SUBJECT: AMENDMENT NO. 130 TO FACILITY OPERATING LICENSE NO. DPR-43 -
 KEWAUNEE NUCLEAR POWER PLANT (TAC NO. M95303)

AMENDMENT TO FACILITY OPERATING LICENSE

Amendment No.130
License No. DPR-43

SAFETY EVALUATION BY THE OFFICE OF NUCLEAR REACTOR REGULATION

**FIGURE TS 3.1-4
 LOW TEMPERATURE OVERPRESSURE PROTECTION CURVE
 APPLICABLE FOR FLUENCE UP TO END OF OPERATING CYCLE 33**

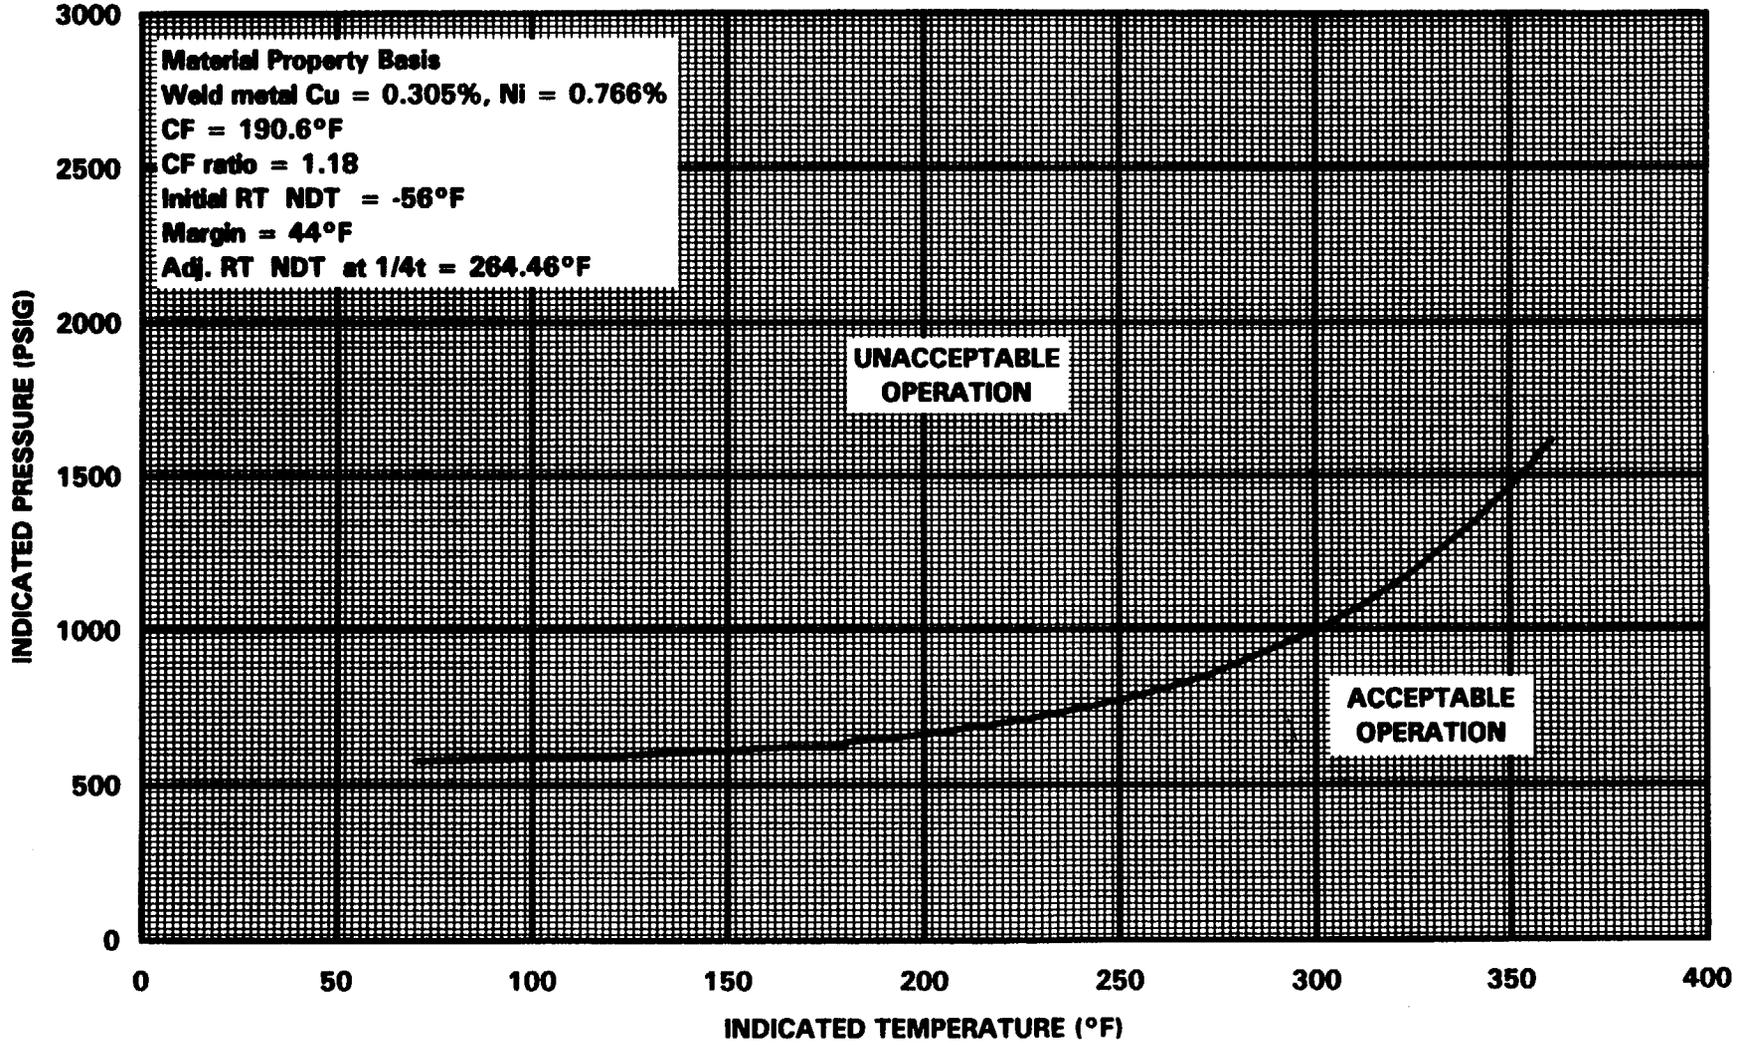
The licensee's proposal would revise TS Figure 3.1-4 to make it applicable up to 33.41 EFPY and change the LTOP enabling temperature to 355°F. No change is proposed for the setpoint of the RHR suction relief valve. The licensee has provided the results of its analysis to confirm that the new LTOP enabling temperature and the current lifting setpoint of the RHR suction relief valve will provide adequate protection to the Appendix G P-T limits established in the proposed TS Figure 3.1-4. The methodology used to evaluate these new setpoints is essentially the same as that previously used for LTOP design at Kewaunee. Proper combined instrument/valve setpoint correction has been factored in the setpoints study. To support the assumption made in the heat

1. TS 3.1.a.C would be revised to increase the required RCS temperature for starting a RCP consistent with the design basis for the LTOP system.
2. TS 3.1.b.1.C and TS 3.1.b.4 would be modified to incorporate a LTOP enabling temperature of 355°F.
3. Figure TS 3.1-4 would be modified to define 10 CFR 50, Appendix G P-T limitations for LTOP evaluation through the end of operating cycle (EOC) 33 which is equivalent to 33.41 EFPY.
4. TS 3.1.b.1 would be modified to reflect the applicability of Figure TS 3.1-4 through EOC 33 or 33.41 EFPY.
5. The Basis for TS 3.1 would be revised to reflect the changes described above.
6. The List of Figures in the Table of Contents would be changed to reflect the revised title of Figure TS 3.1-4 indicating the new expiration date of EOC 33.

- C. Figure TS 3.1-4 defines limits to assure prevention of non-ductile failure applicable to low temperature overpressurization events only. Application of this curve is limited to evaluation of LTOP events whenever one or more of the RCS cold leg temperatures are less than or equal to the LTOP enabling temperature of 355°F.

A limit curve (Figure TS 3.1-4) for evaluation of low temperature overpressure protection (LTOP) events has been calculated using the methodology of 10 CFR 50.61(c)(2). The derivation of the LTOP evaluation curve is consistent with Footnotes⁽¹⁶⁾⁽¹⁷⁾. This curve is applicable for 33.41 effective full-power years of fluence (through the end of operating cycle 33). If a low temperature overpressure event occurred, the RCS pressure transient would be evaluated to the limits of this figure to verify the integrity of the reactor vessel. If these limits are not exceeded, vessel integrity is assured and a TS violation has not occurred.
